CMI-331

AUDIO OUTPUT MODULE

FIELD CHANGE NOTICE

DESCRIPTION Audio Output Module

ESP-399 SAMPLE & HOLD CONNECTIONS

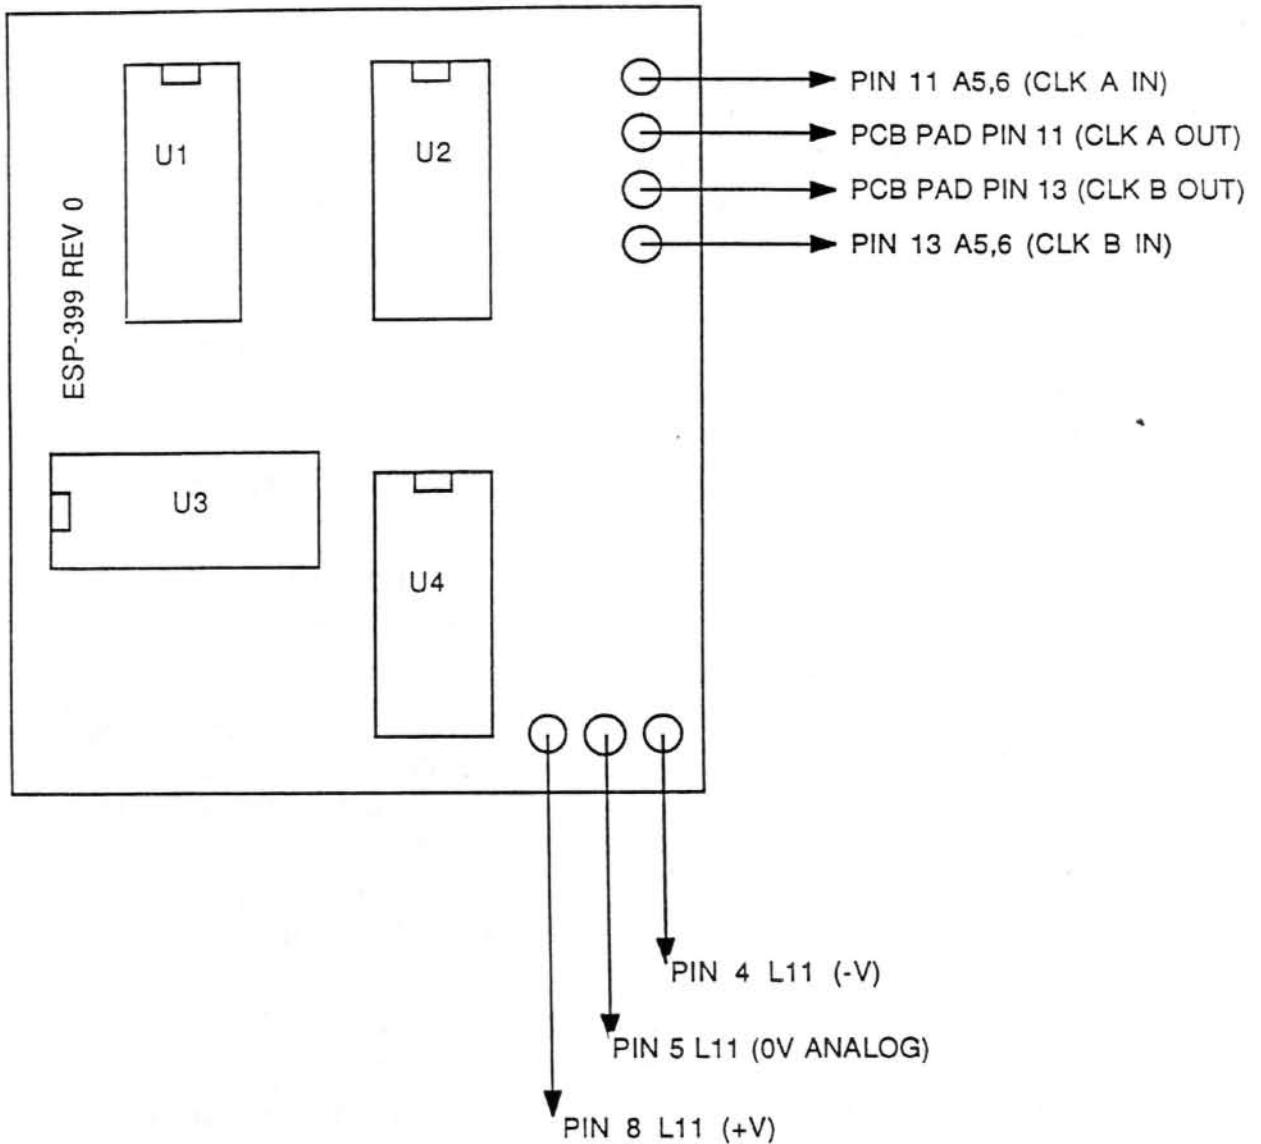
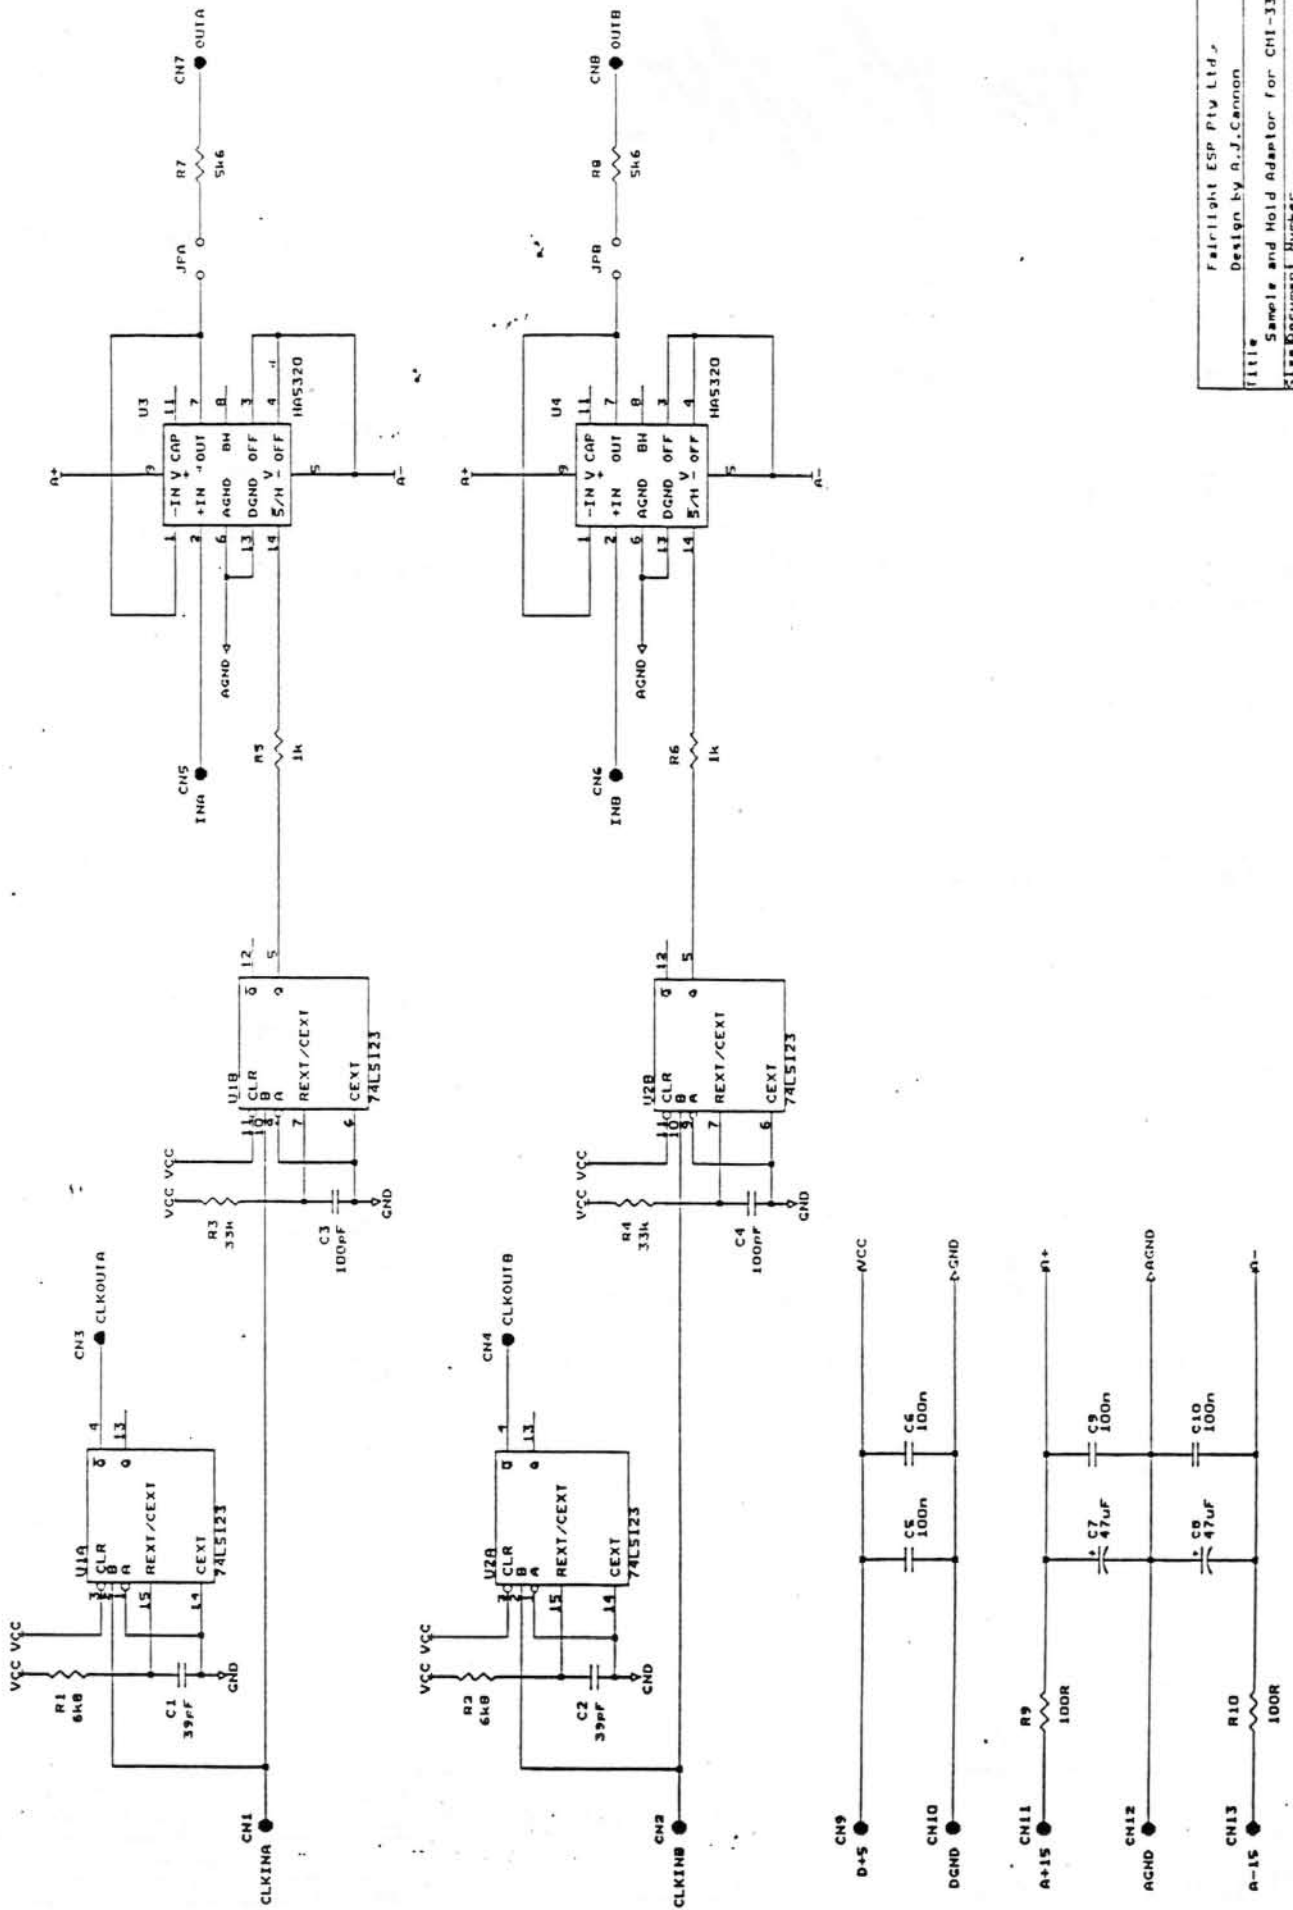
To remove low level distortion from the audio output signal.

1. Remove R78 and R80.
2. Remove R79 and place on solder side of CMI-331. Cut resistor legs so they do not protrude through the pcb on the component side.
3. Unsolder and CAREFULLY lift pins 11 and 13 of IC A5,6.
4. Remove C11.
5. Desolder pins 4,5, and 8 of IC L11 OR if IC L11 is used solder directly onto pins. See point 9.
6. Remove the centre pin of the 3 x 3 way vertical connectors. Plug "3 way" vertical pins into the 3 x female sockets on solder side of ESP-399.
- 7.a Connect "clock A out" to isolated PCB pad at pin 11 IC A5,6.
- 7.b Connect "clock B out" to isolated PCB pad at pin 13 IC A5,6.
- 7.c Connect "clock A in" directly to pin 11 of IC A5,6.
- 7.d Connect "clock B in" directly to pin 13 of IC A5,6,7.

After the 4 connections have been made CAREFULLY fold cable, and attached ESP-399 assy. over IC A5,6 then do an immediate right angle fold toward R2 / R3 then at R2 / R3 right angle fold toward centre of CMI-331. Then one last right angle fold to be able to install at C11, R80 and R78.

8. Check that the height of ESP-399 is within the module width, i.e. that all connectors are flush with the pcb.
9. Connect analog power and analog ground at IC L11. Pin 4 -V, pin 5 analog ground, pin 8 +V. See connection diagram.
10. Check all connections. Plug CMI-331 into extender and turn machine on.
11. At step 1 of audio cal press "SET" then "A" SPACE BAR then type "60" <return>. With test unit with 20Hz to 20kHz filter ON THD+N will be better than -30dB or 5% THD+N.

SUBJECT: TRACK CUTS FOR REVISION 1B.9 AND TO BE CHECKED ON 1B7.2

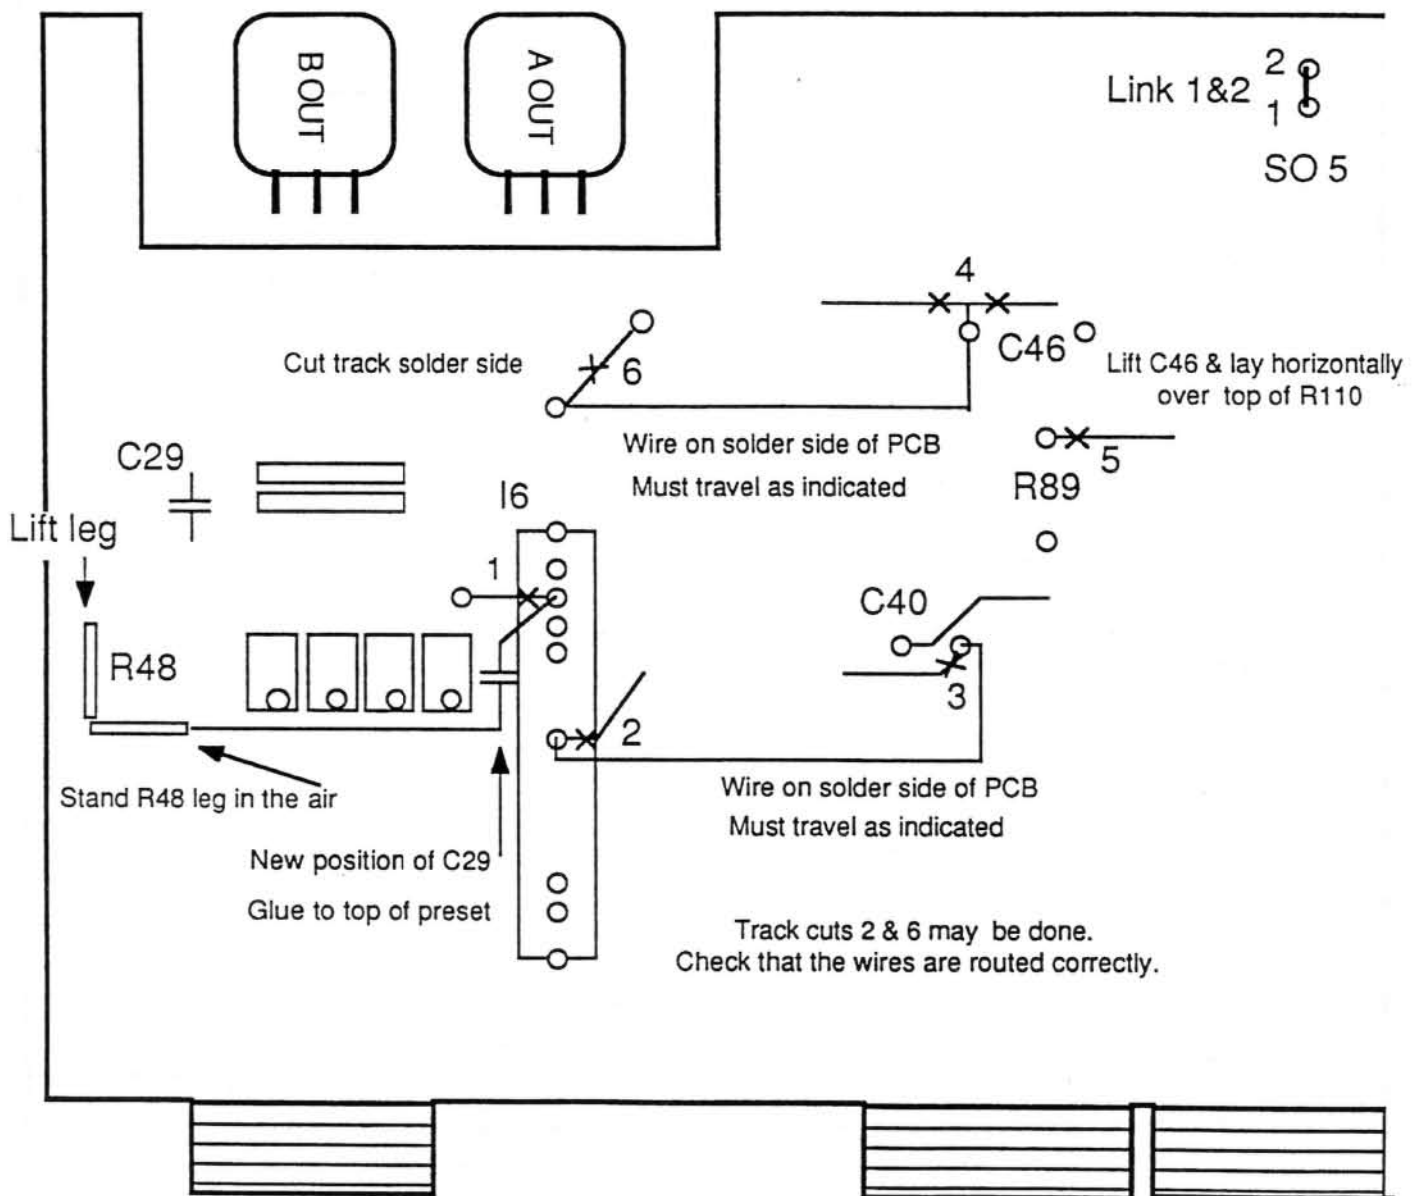
The following track cuts and modifications must be done to the audio output card to remove cross talk.

1. Cut track at PIN 5 of I6 (PALH 1107E). Component side.
2. Cut track at via hole. (PALH 1107E). Component side.
3. Cut track at C40. Component side.
4. Cut tracks at C46. Component side.
5. Cut track at R89. Component side
6. Cut track solder side.

NOTE: Track cuts 1,2,3,4 & 6 are associated with track routing changes. See sample.

VCF CONTROL MODIFICATIONS

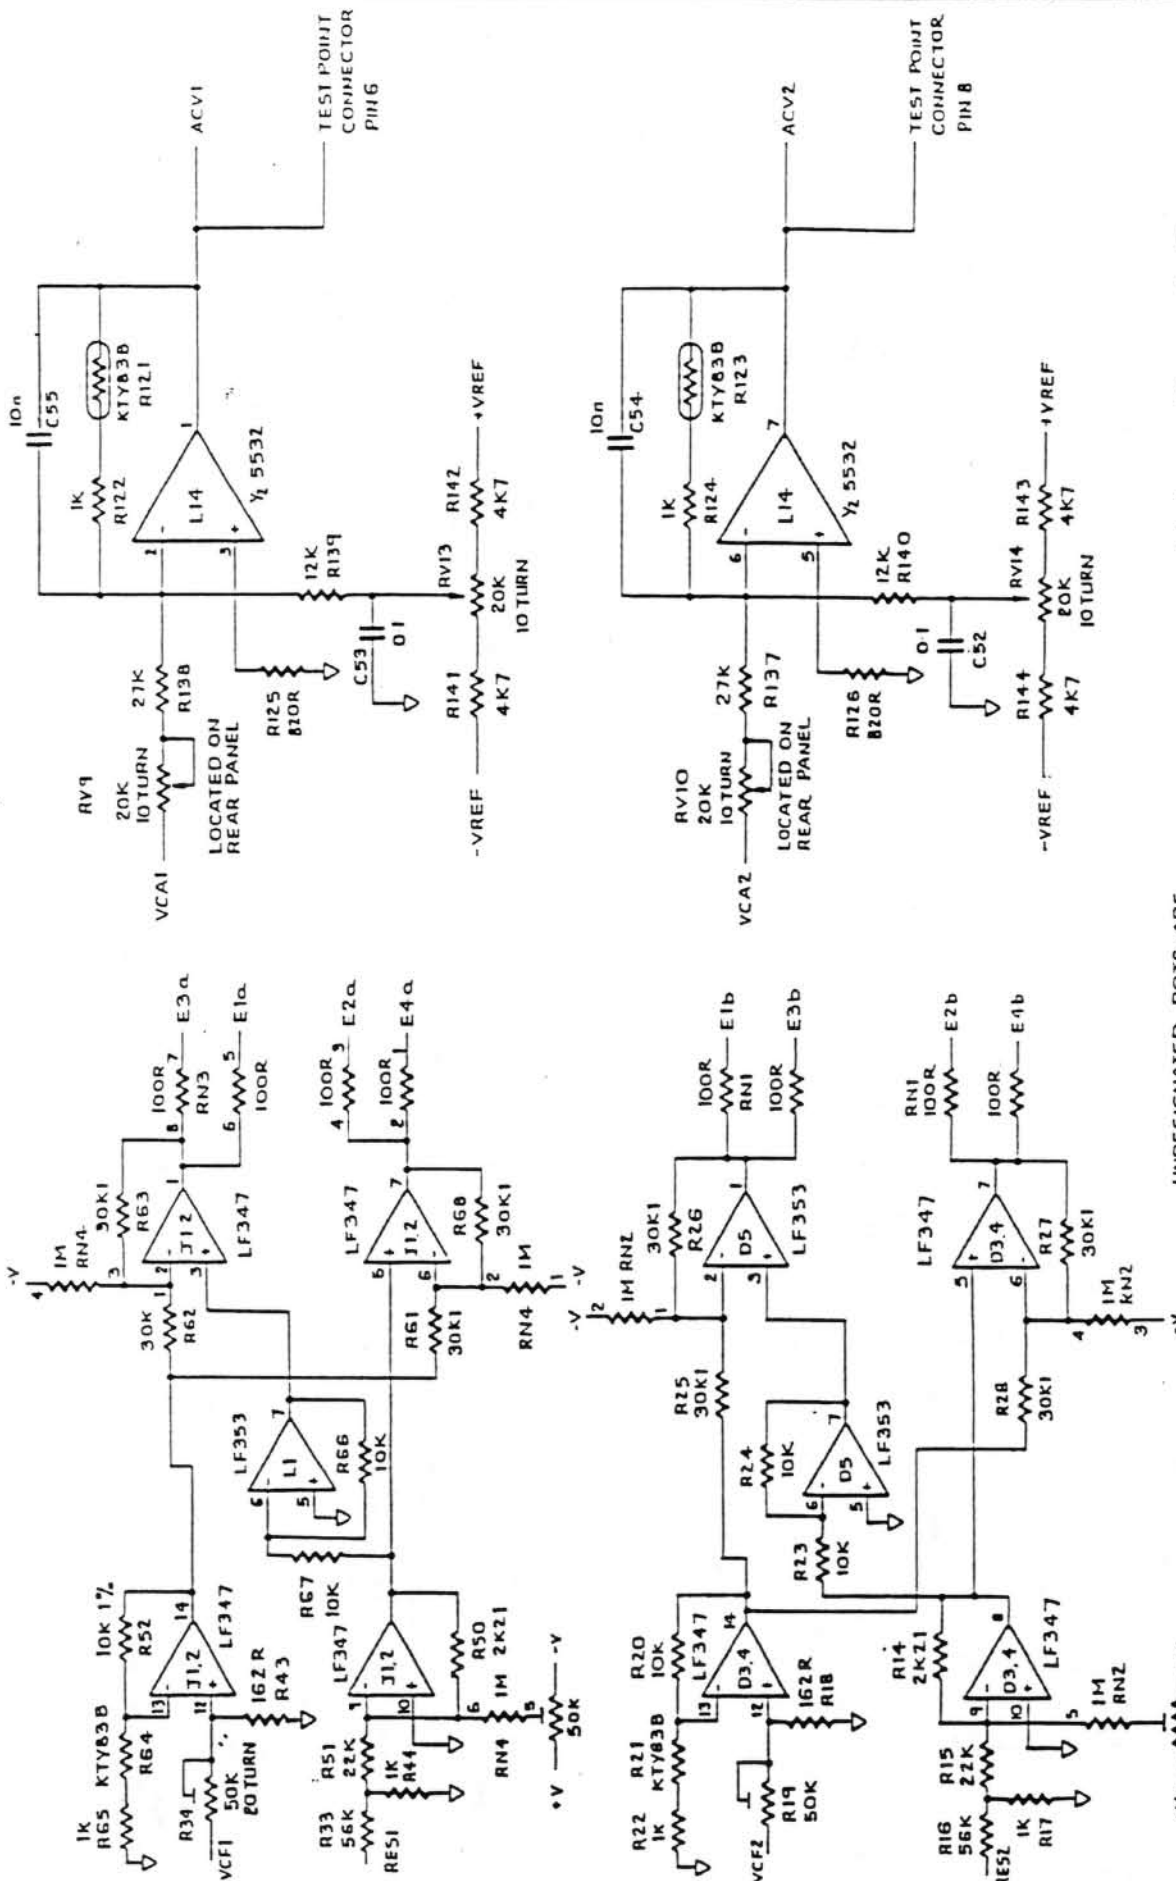
REMOVE RN - 4

Place between 5 & 6 Discrete Imeg resistor and wire to "1st" 50K pot (see circuit)

REPLACE R43 (162ohm) with 270 ohm

ADD 30K from pin 12 (J1,2) to -Vref

ADD 220k from pin12 (J1,2) to center of "2nd" 50K pot

Mount 50K pots on J1,2

ADD 100n across R63 & R68

REMOVE RN - 2

Place between 5 & 6 Discrete Imeg resistor and wire to "1st" 50K pot (see circuit)

REPLACE R18 (162ohm) with 270 ohm

ADD 30K from pin 12 (D3,4) to -Vref

ADD 220k from pin12 (D3,4) to center of "2nd" 50K pot

Mount 50K pots on D 3,4

ADD 100n across R26 & R27

Voltage Controls For VCA'S & VCFA'S

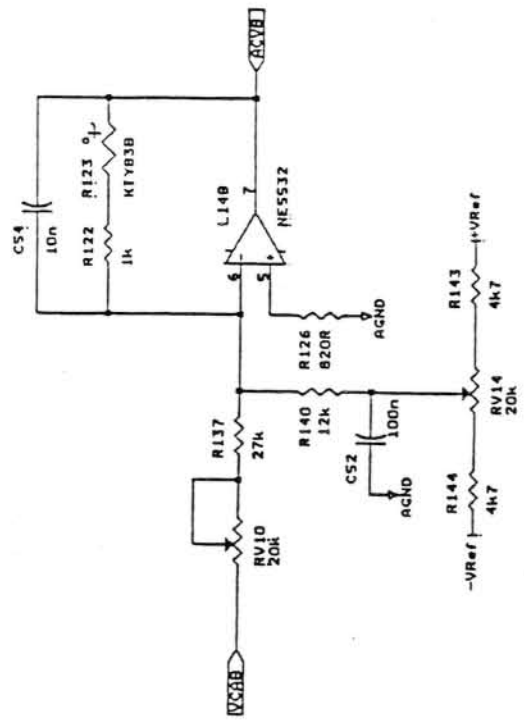
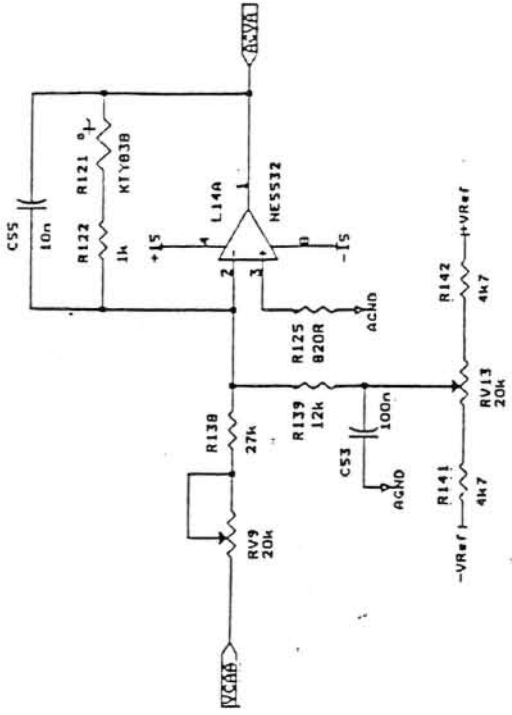
NOTE: Changes to VCF Resistor Values if this Circuit is used.
